**Project:** Wickham Woolstore Development – Building 1

**Report:** BCA Assessment Report – DA Version

**Reference No:** 107528-BCA-r1

### 4. Fire Hydrants – BCA Clause E1.3

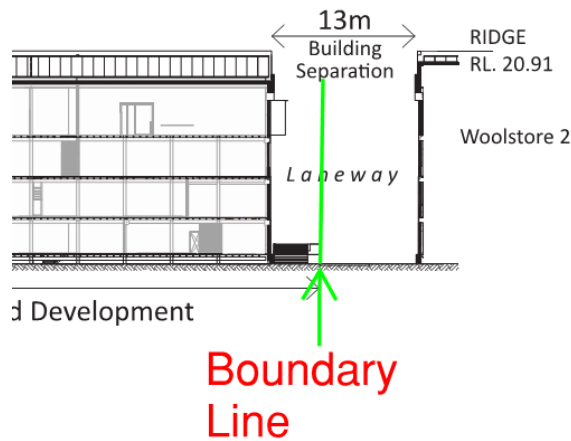
The location of the fire hydrant booster being on the southern elevation is within sight of the main entrance in accordance with AS2419.1-2005, however radiant heat protection behind such booster is not proposed as part of the design. As such this issue will be addressed as a Performance Solution at the Construction Certificate Stage. The solution will be based on the draft requirements of AS2419.1-2016 that detail in a fully sprinkler protected building – radiant heat protection is not required to the Booster Assembly.

### 3. Light and Ventilation – BCA Clause F4.1 & F4.6

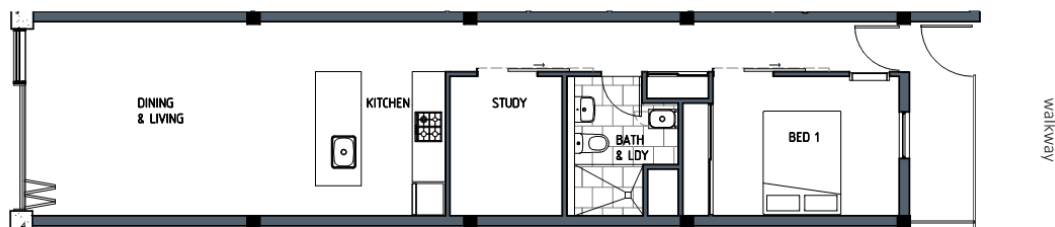
Generally, all habitable rooms at levels 1, 2 and most of level 3 have direct access to natural light and ventilation either via direct light and ventilation or borrowed light and ventilation. Of particular note is the natural light and ventilation provisions to the level 3, 4 and Level 4 Mezzanine portions.

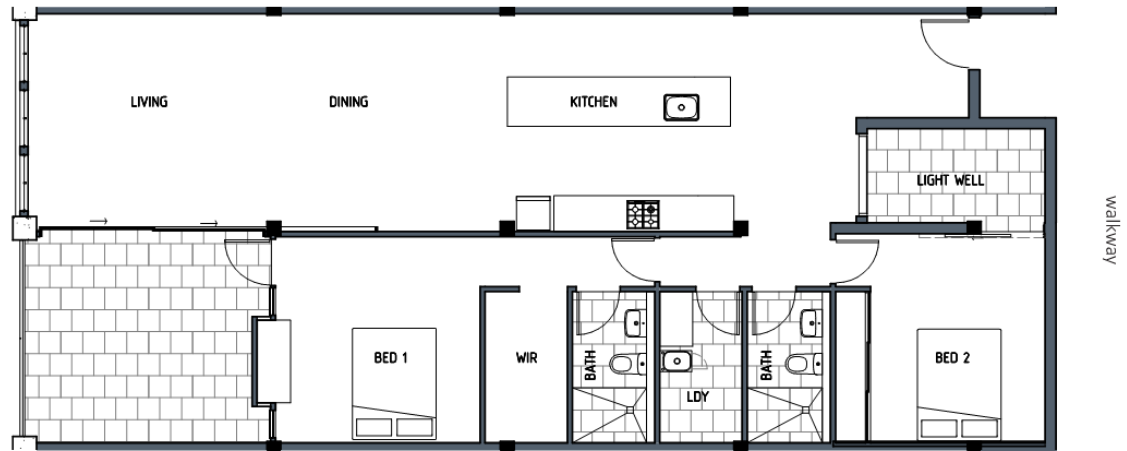
Essentially the level 3 portions that have bedrooms facing the central circulation / corridor area will have either windows that will need to be suitably fire rated to achieve a -/60/- FRL to satisfy C3.11 of BCA2016. The natural light to these areas being borrowed light will need to be assessed as a Performance Solution Assessment at the Construction Certificate Stage. The ventilation to these rooms will need to be mechanically ventilated as such bedrooms will not have access to natural ventilation means.

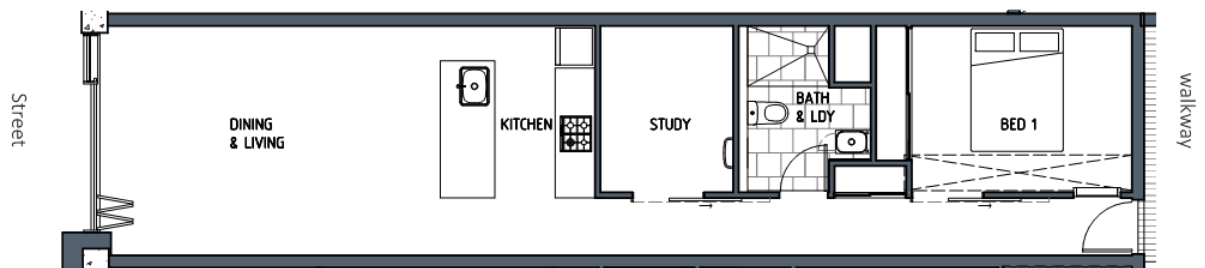
Other situations at level 3 include the creation of light wells down through the building to serve the rear bedrooms as per below:

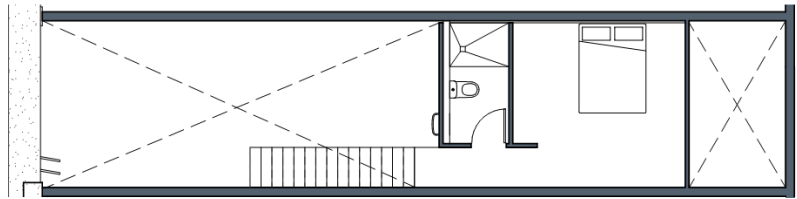
The natural light and ventilation to the level 4 bedrooms that adjoin the central circulation area will be served via light shafts and over the internal unit corridor from the above south facing sawtooth roof windows.

Level 4 Mezzanine

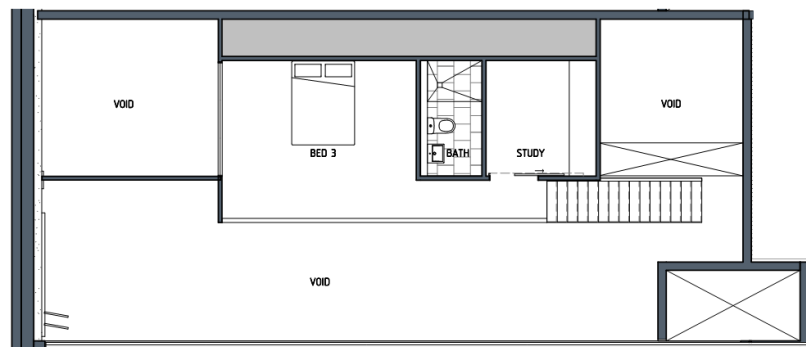
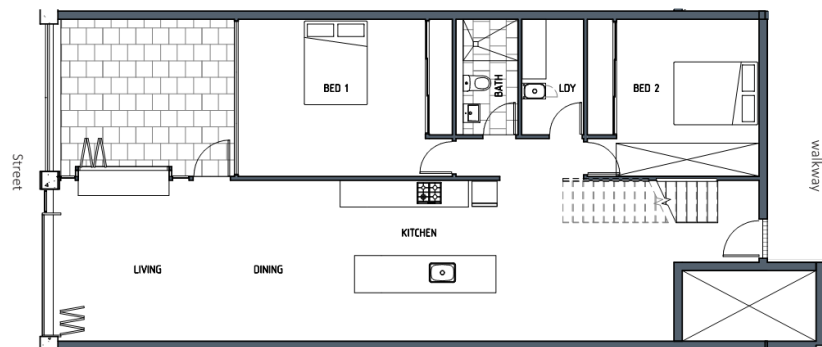
The level 4 mezzanine bedrooms will also be gaining their natural light from the south facing sawtooth roof windows.

At the Construction Certificate stage a detailed assessment of the natural light and ventilation provisions will be required for each SOU.
